CITY PROJECT NO. 14079
CONTRACT NO. 8709

ADDENDUM #1- 5/17/2024
REVISED THE
FOLLOWING:
TITLE SHEET
GI2-GI5, PD1-PD2, PD5-
PD6, P1-P2, P5-P6, U2-U6
REMOVED THE
FOLLOWING:
GI2 AND GI6

REVISION #1- 8/15/2024
REVISED THE
FOLLOWING:
EC4, EC6, GI1, GI3-GI5,
PD2-PD6, P2-P6, U4-U5,
W1, X4-X5, X7, X9, X12

REVISION 2: 3/21/25
REVISED THE
FOLLOWING:
P2, P3, PD2, PD3, U1, U2,
U3, U7

14079		MADISON, WI		8709		PD-2	
PLAN DETAILS BEVERLY ROAD		DONCASTER BEVERLY DANBURY RECONSTRUCTION		CONTRACT NO.:			
CITY OF MADISON WISCONSIN		M:\DESIGN\Projects\14079\CAD\Streets\14079EN-PnP.dwg					
14079		PD-2

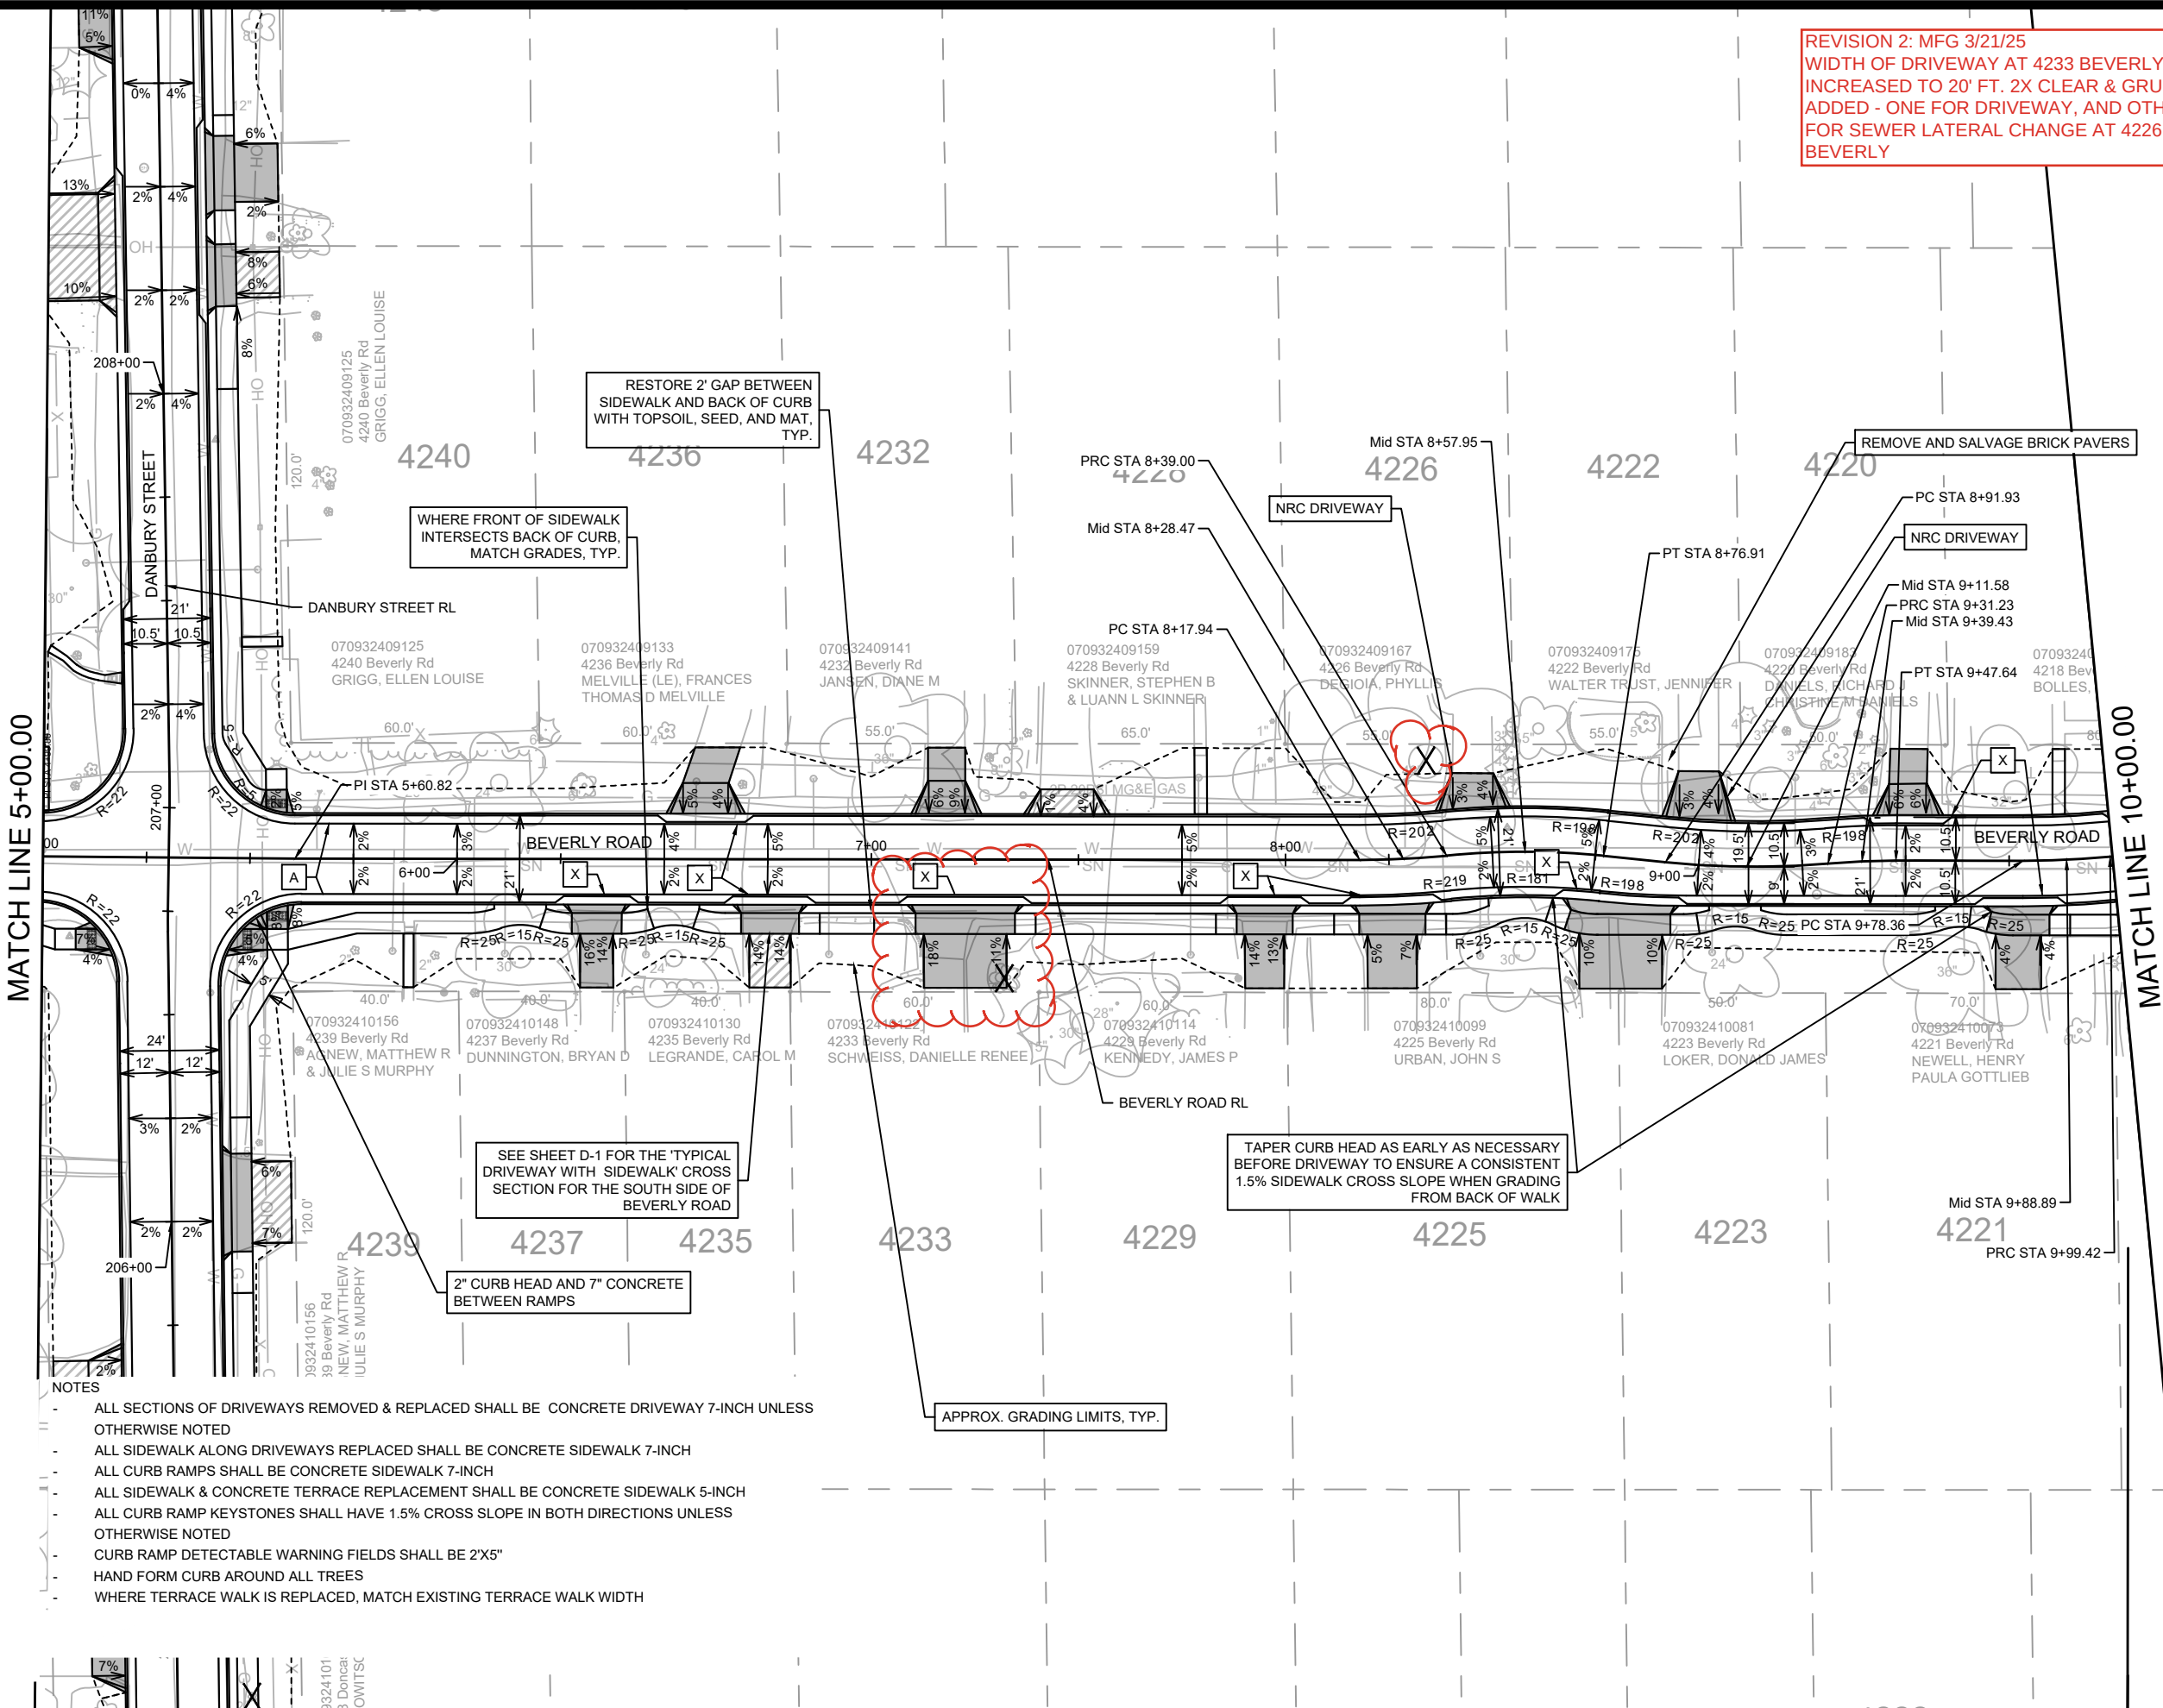
REVISION 2: MFG 3/21/25
 WIDTH OF DRIVEWAY AT 4233 BEVERLY
 INCREASED TO 20' FT. 2X CLEAR & GRUB
 ADDED - ONE FOR DRIVEWAY, AND OTHER
 FOR SEWER LATERAL CHANGE AT 4226
 BEVERLY

14079
PD-5

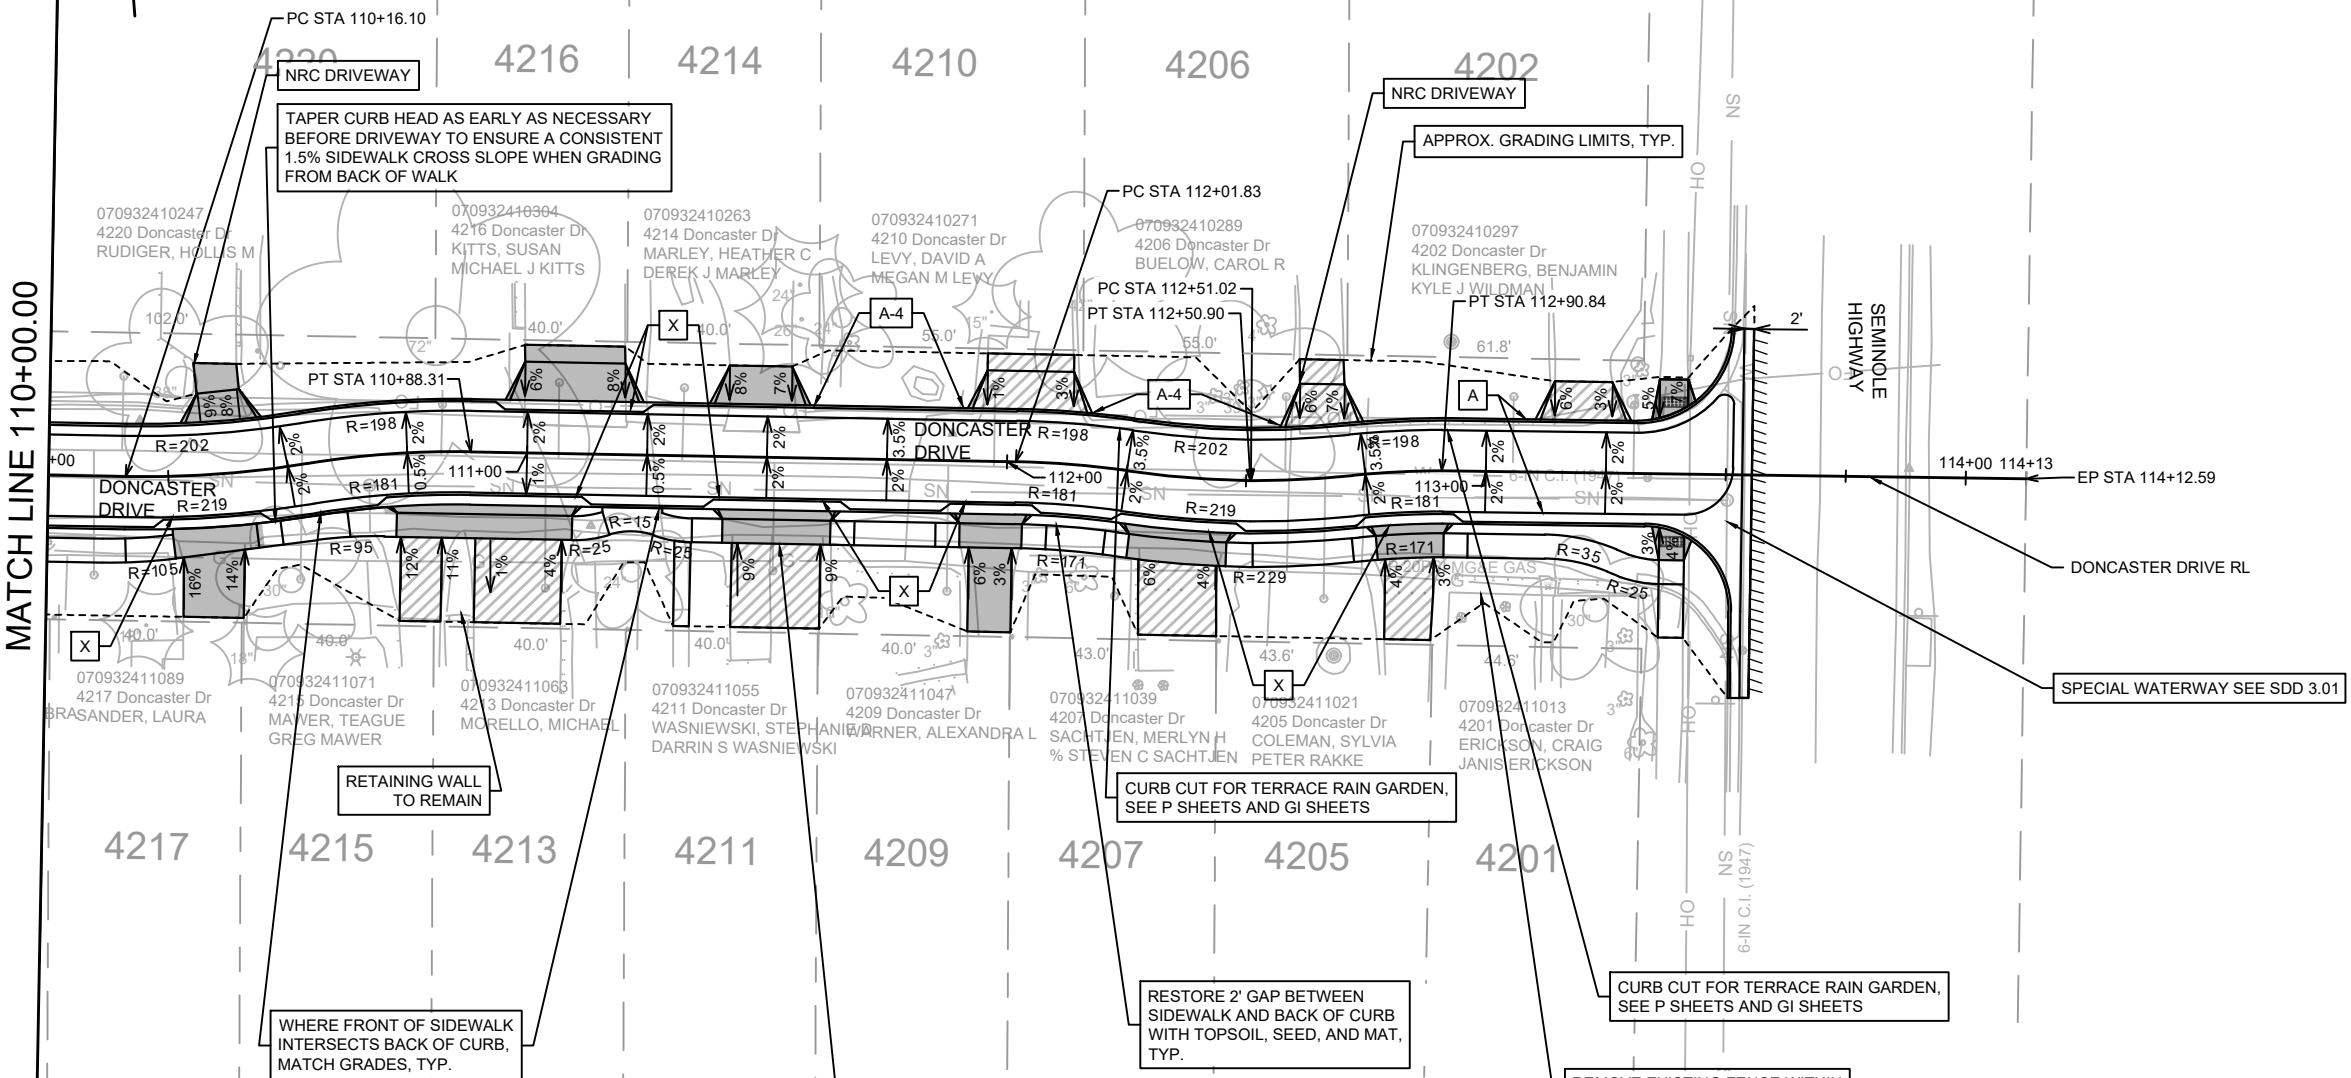
REVISION 1:
UPDATED DRIVEWAYS
TO MATCH LATERAL
GEOMETRY

P-2

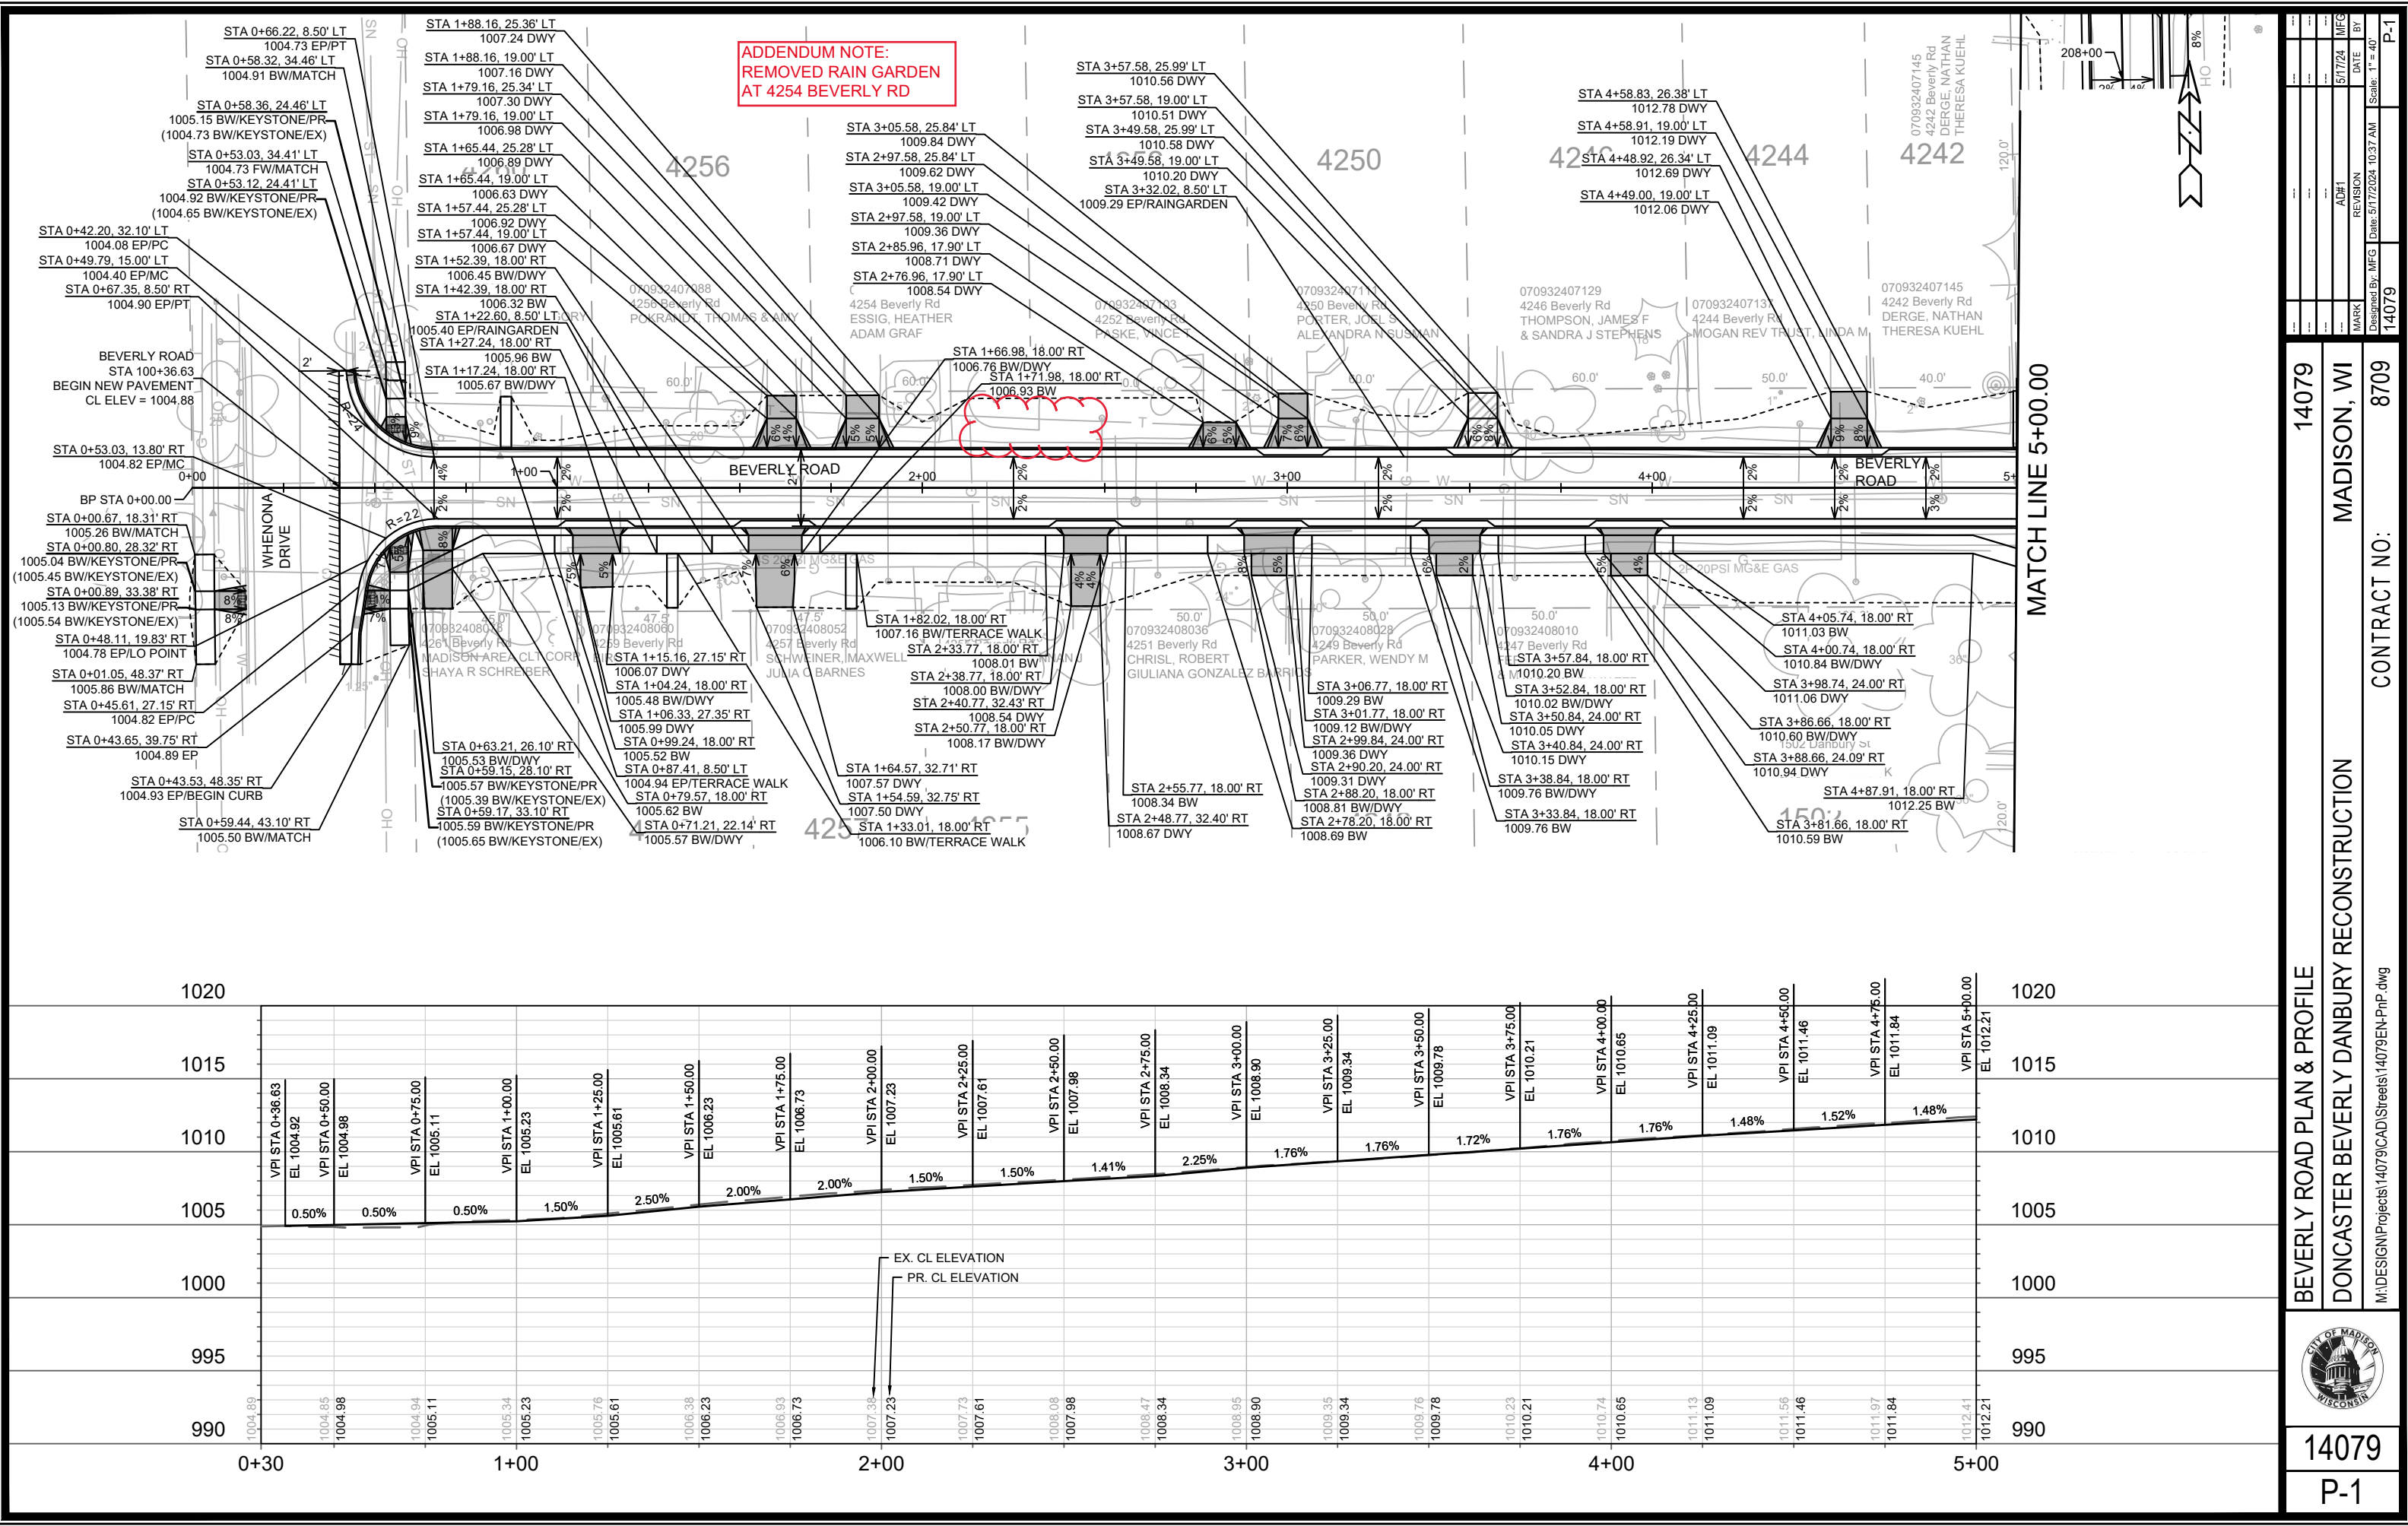
REVISION 2: MFG 3/21/25
UPDATED TO MATCH PD SHEETS
